TO: Mr. R. Marshall
FROM: B. K. Culver
SUBJECT: Wm. H. Zimmer Nuclear Power Station
Unit 1 - P/W Weldment Analysis
W.O. 57300, Job E-5590, Spec. H-2803.23

OBJECTIVE: Review of documented welding requirements specifically related to P & W Fabricated Hangers with critical Visual Inspection of presented weldments and panel rebuttal commentary of evaluation opinions.

MEETING WITH P/W ON SPECIFICATION H-2803 CABLE TRAY HANGERS
MARCH 5, 1980

Subject S&L Std. EB-117, Dwg. E-189 and Dwg. E-13.3
Detail 27

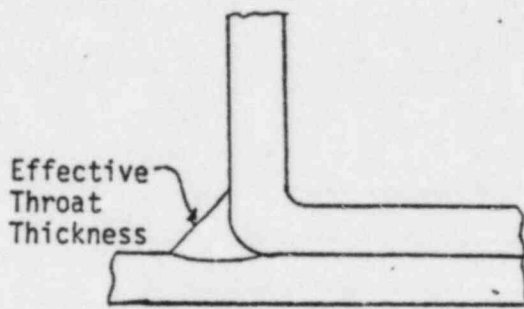
THE WELD SYMBOL SHOWN ON DRWG. E-13-3 DETAIL 27, L STD. EB-117, DRWG. E-189, AND VARIOUS OTHER DESIGN DOCUMENTS INDICATE FILLET WELDS WHERE THE SIDES OF RIG TRUSS MEMBERS AND BOX IRON ARE WELDED TO PLATES, ANGLES, CABLE TRAYS, ETC. CONTRARY TO THE ABOVE, THE GEOMETRY OF THIS CONNECTION INDICATES A FLARE-BEVEL GROOVE WELD SHOULD BE USED. (SEE ATTACHMENT) WHAT TYPE OF WELD IS THIS? HOW DOES QA VERIFY COMPLIANCE?

Answer: The two manufacturers of struts gives all the dimensions for the channels, except for corner radius. Since there is no radius specified and therefore no tolerance, there is no dimensional control. If a flare bevel groove weld of a certain size is specified and the radius of the channel is less, then the channel would have to be reworked by grinding prior to welding. The thickness of the majority of the channels are as follows:

EB-117 shows a standard fillet weld. This is prequalified by AWS D1.1. It should also be noted in paragraph 3.3.1, AWS D1.1, that the root gap can go to 3/16" maximum provided that if the separation (gap) is 1/16" or greater, the leg of the fillet weld shall be increased by the amount of the separation. The slight radius on the channel is, for your purposes, classified as the root gap. Based on all of the above, the fillet weld shown in EB-117 are suitable and the flare-bevel groove symbol should not be used.

Answer: Welds should be visually examined to AWS D1.1 criteria, weld size checked with the appropriate weld gauge and all results documented.

Figure 11-11. Groove weld symbols.

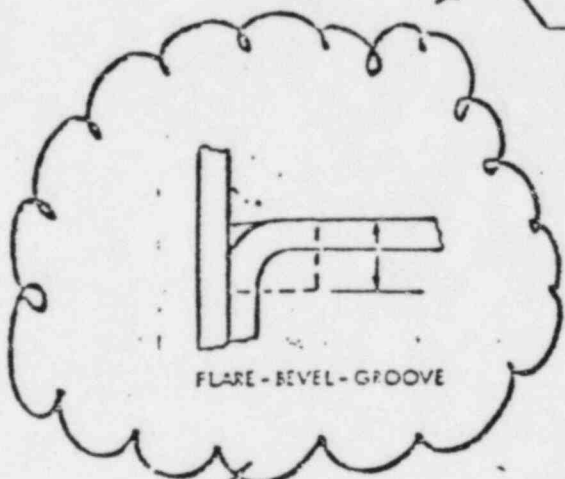
The reference report states that the subject EB-117 drawings indicates fillet welds where the strut is welded to the plates, angles, cable trays, etc., where the geometry of the connection indicates a flare-bevel groove weld should be used. It also asks the following questions:

The majority of contractors who fabricate these hangers use prequalified welding procedures to AWS D1.1. It should be noted that a flare-bevel groove is not a prequalified joint and, therefore, the welding procedure would have to be qualified.
